Ray, #401 and Fraser Road Instrumentation
W. J. 66-F-84 -- Contract No. 66-179

Fraser Road Underpass, W.P. 107-59, Contract 67-18,
Highway 401, Site No. 67-18, District No. 9

SOIL CONDITIONS AND FOUNDATIONS

PROPOSED FRASER ROAD UNDERPASS

DRAWING NO. 66-F-84 C

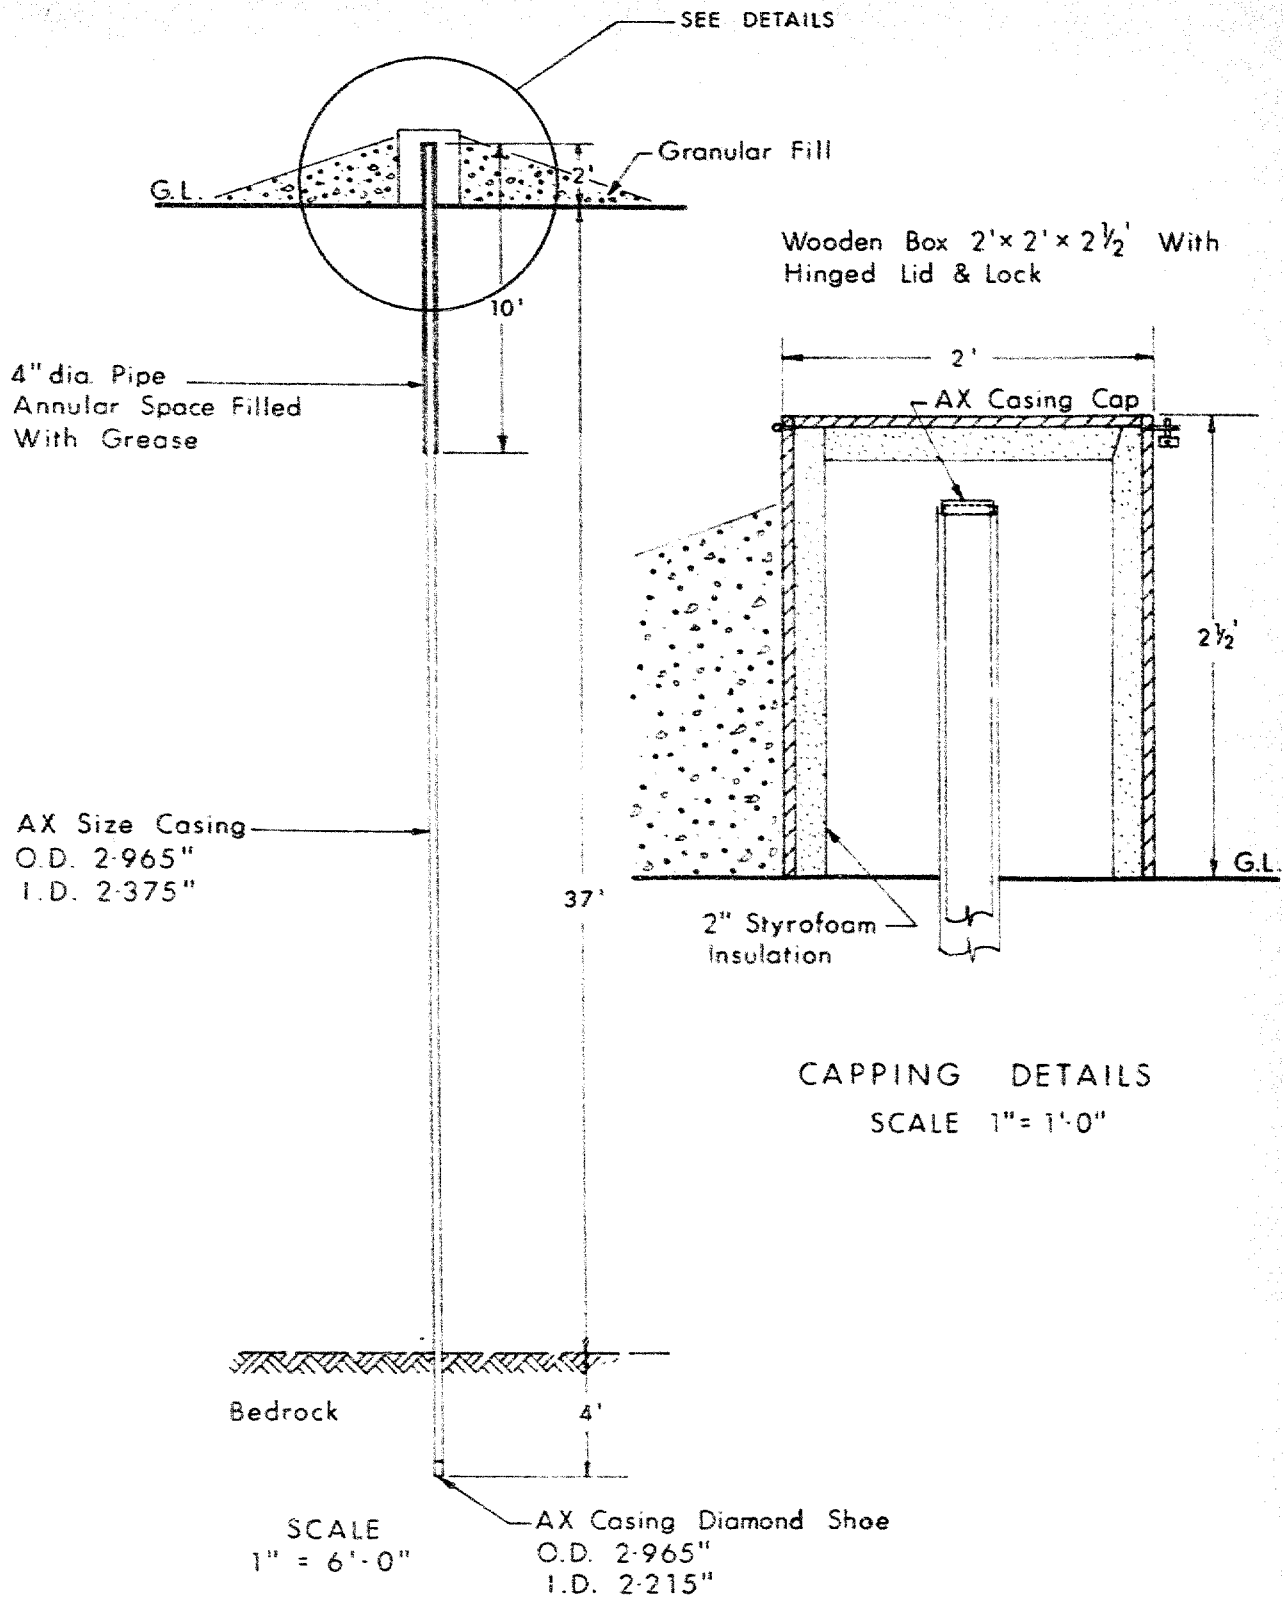
At the above mentioned location, we would like to install a vent pipe to the C.I.P. culvert which is now in place.

The details of this vent pipe and the required location are shown on the enclosed drawing.

Would you please make the necessary arrangements to have this work carried out.

DRAWING NO. 66-F-84 B

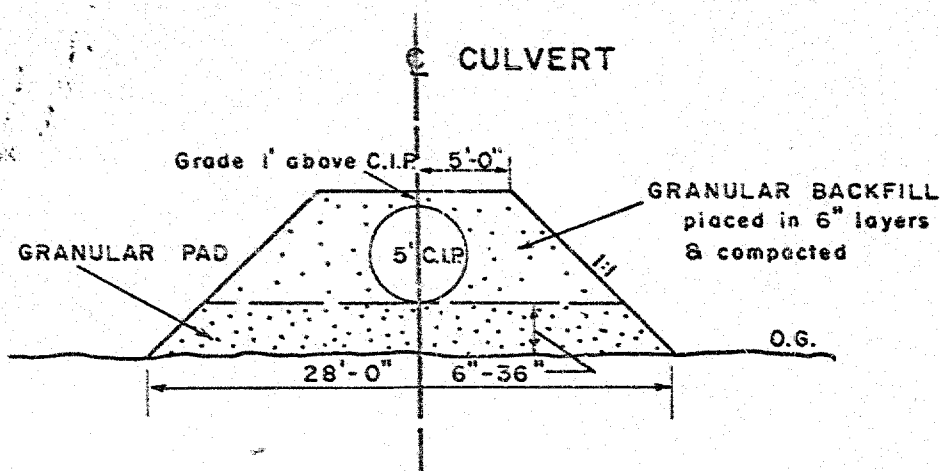
Further to our telephone conversation, we are enclosing a drawing showing the details of the culvert proposed for the above mentioned instrumentation project. We have also detailed on the drawing the various quantities required for placing of the culvert. We feel that 3-ft. square holes should be cut with a torch in the bottom of the culvert at the predetermined distances prior to placing the culvert over the instrumentation area.
